REMARKS

In the Office Action of September 1, 2004, the Examiner (1) objected to the drawings, (2) objected to the specification and (3) rejected claims 1-3, 7-11, 14, 15 and 19-21, which are all of the pending claims. Applicant will respond to the issues presented in the Office Action, in the order in which they were raised.

Docket No.: T0461.70003 US00
Date: December 22, 2004
x01/01/05

Fig. 6A

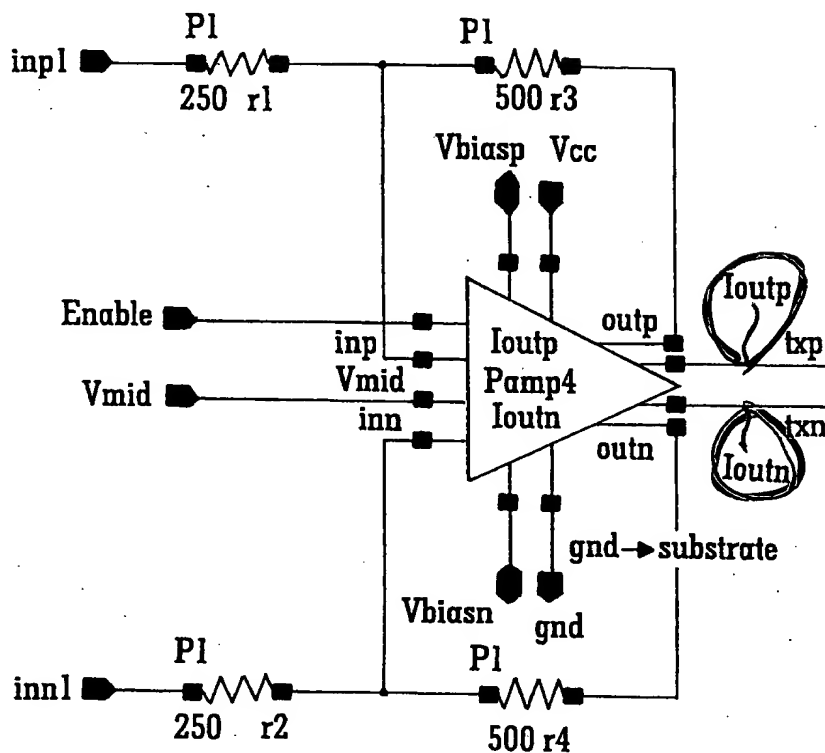
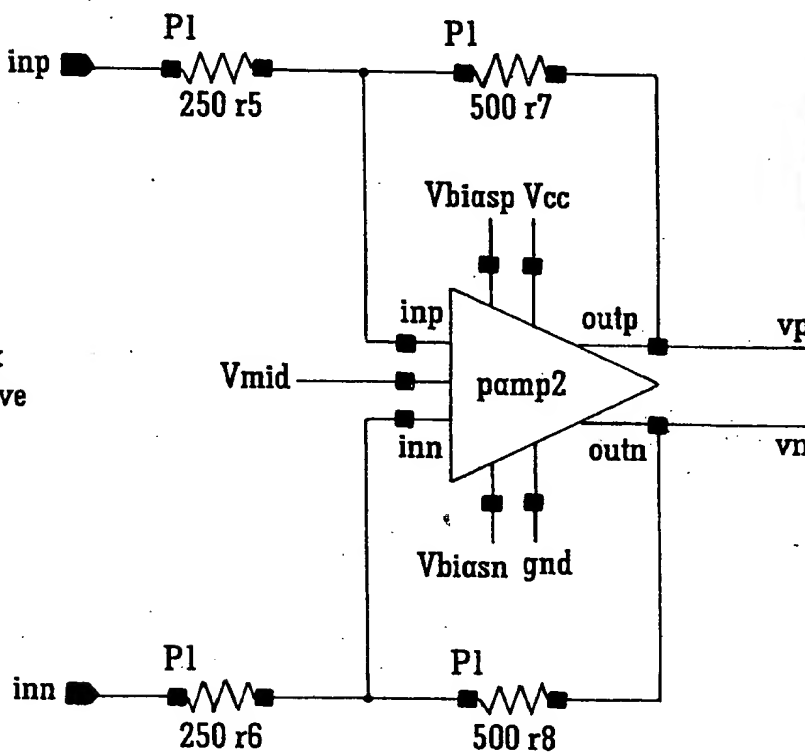
Figs. 6A and 8 are amended to conform their output terminal and signal labels.

To expand somewhat, if the voltage vp is higher than the voltage Vmid, then resistor r7 (Fig. 6A) pulls up on the input inp and turns off transistor mn1, allowing transistor mp6 to pull up on the gate of transistor mp2. This turns off transistor mp2, allowing transistor mn2 to pull down on the terminal vp. This negative feedback stops when the voltage on terminal vp equals vmid. A mirror image operation occurs with respect to the voltage on terminal vn.

Regarding claim 3, the Examiner objects to, as indefinite due to misdescriptiveness, the recitation "a logic control input signal enabling and disabling the first driving means; and a logical complement of the logic control signal for enabling and disabling the second driving means." He asserts that Figs. 5 or 6 or 6A show only one control signal applied to the first

Applicant has also amended Figs. 6A and 8 to make consistent the labeling of outputs of Pamp 4. Copies of those figures marked in red and labeled "Annotated Sheet Showing Changes" are attached, along with Replacement Sheets for Figs. 1-8 and a new sheet for Fig. 9.

Fig. 8

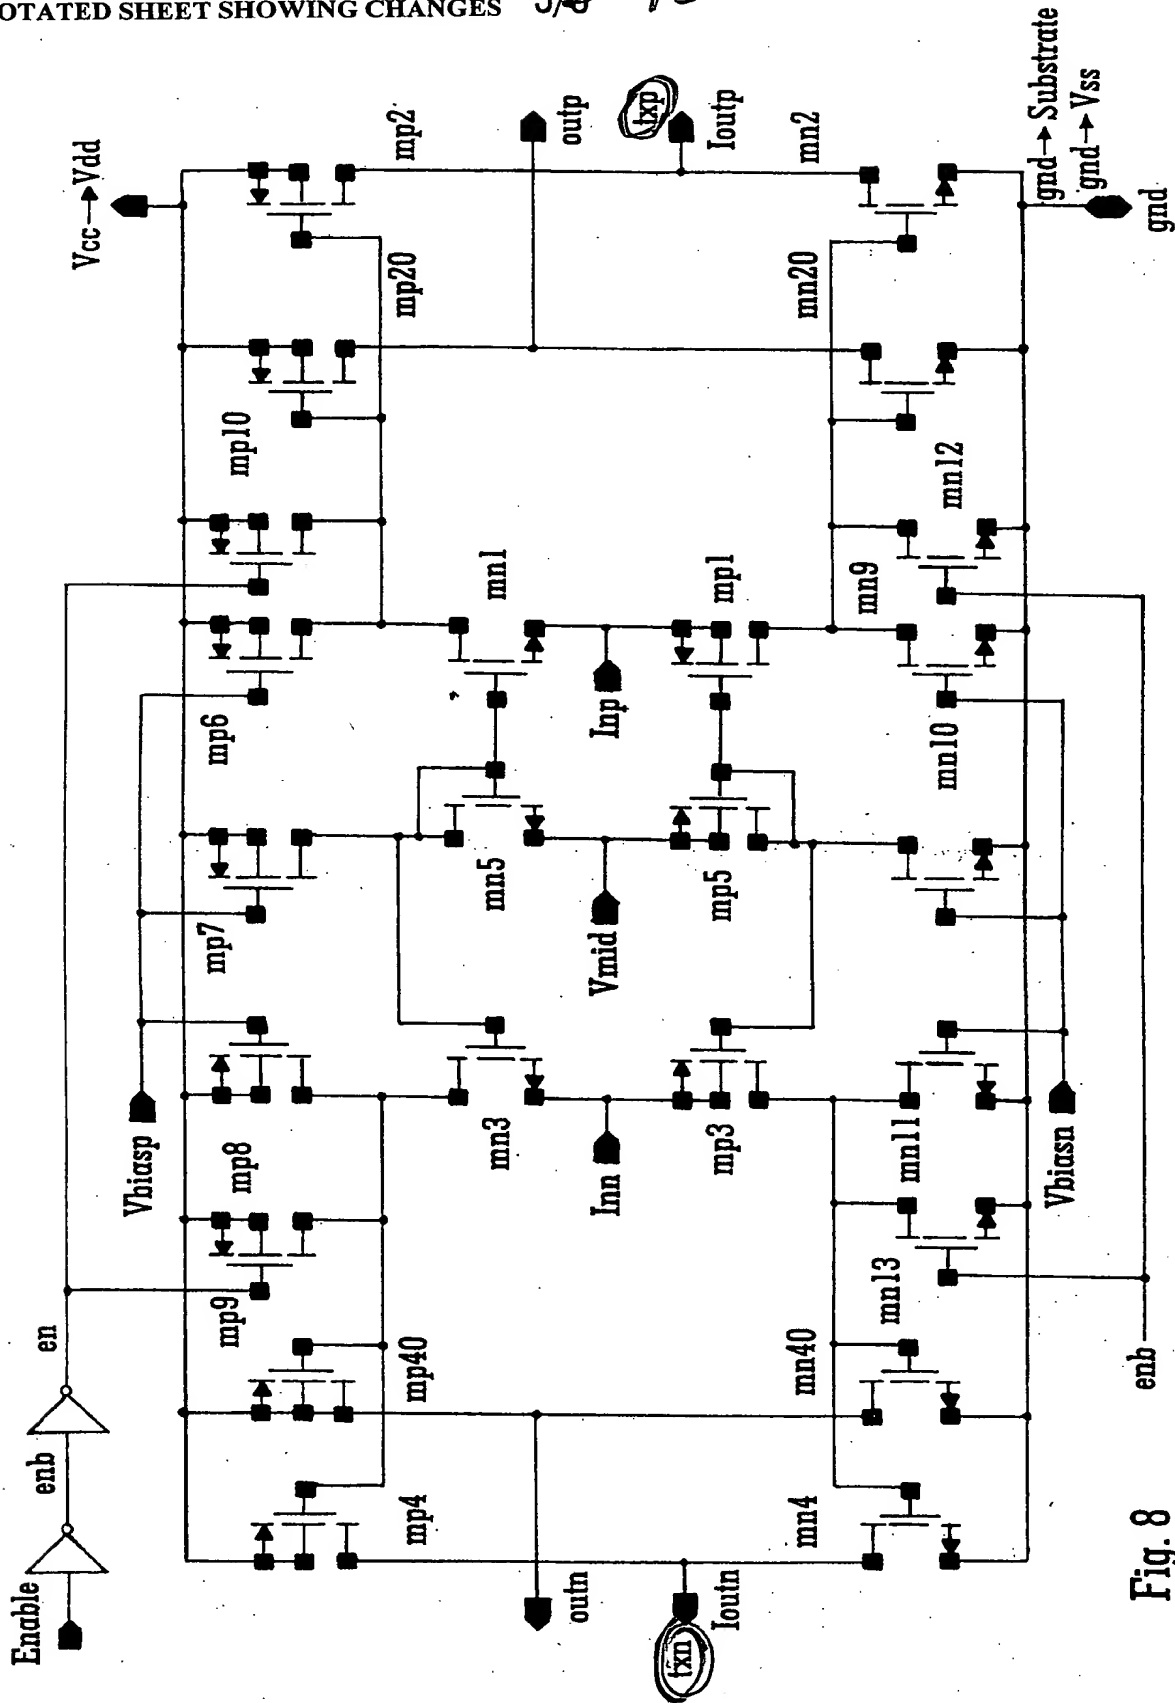
With reference to pages 13 and 14, we note first the statement on page 14, in the paragraph spanning lines 6 -11, that the switched current feedback amplifier Pamp4 of Fig. 6 (further illustrated in the example circuit of Fig. 8) is similar to the Fig. 7 amplifier. We further refer to the discussion of Fig. 7 amplifier Pamp2 on page 13. There, it is explained from lines 24-35 how vmid couples to the termination elements. Indeed, the relationship between the voltage on the input terminals and vmid determines whether current flows in the input terminals. If so, this signal current is converted to a voltage gain which drives the current at outp flowing from vcc to outp. Or, with the reverse polarity, when the input Inp is below vmid, then the current flowing in transistor mp1 is the current Imn9 minus the signal current. After signal current is converted to a voltage gain, that voltage drives the output device to reduce the current flowing from outp to ground. The mid-point termination voltage is thereby coupled to the termination elements which receive the output. The coupling is fully shown in Figs. 7 and 8.

To further expound, the signal path is differential. Vmid is a voltage reference input. Starting from that reference input, the voltage at the gates of transistors mn1, mn3 and mn5 is equal to $V_{mid} + V_{gs_{mn5}}$ (where V_{gsx} is the gate-to-source voltage of transistor x). From the specification at page 13, line 7, transistor mp7 will conduct some known current. (Note that mp7 apparently is a depletion mode device.) This known current from transistor mp7 flows in the diode-connected transistor mn5 and thus sets the value of $V_{gs_{mn5}}$. Similarly, transistor mn10 establishes a current in transistor mp5 and that current, in turn, sets a voltage at the gates of transistors mp1, mp3 and mp5, equal to $V_{mid} - V_{gs_{mp5}}$. If input inp is at a voltage equal to reference Vmid, then transistor mn1 will have a gate-to-source voltage (V_{gs}) equal to the gate-to-source voltage of transistor mn5, and transistor mp1 will have a V_{gs} equal to the V_{gs} of mp5.

This means that transistor mn1 will conduct a current equal to the current in transistor mn5 and transistor mp1 will conduct a current equal to the current in transistor mp5. Likewise, transistor mp6 will conduct a current equal to that of transistor mp7, and transistor mn9 makes a current equal to that of transistor mn10. So, the currents from transistors mp6 and mn1 balance and the voltage at the gate of transistor mp2 can stay at its initial point. Similarly, the current from transistors mn9 and mp1 balance and the voltage at the gate of transistor mn2 can stay at its initial point. If the voltage input inp is lower than the voltage Vmid, then transistor mn1 turns on harder, pulling down on the gate of transistor mp2. This turns on device mp2 and pulls up on the output outp; also, transistor mp1 turns off and transistor mn9 can pull down on the gate of transistor mn2, turning off transistor mn2 and allowing the output outp to be pulled up by transistor mp2.
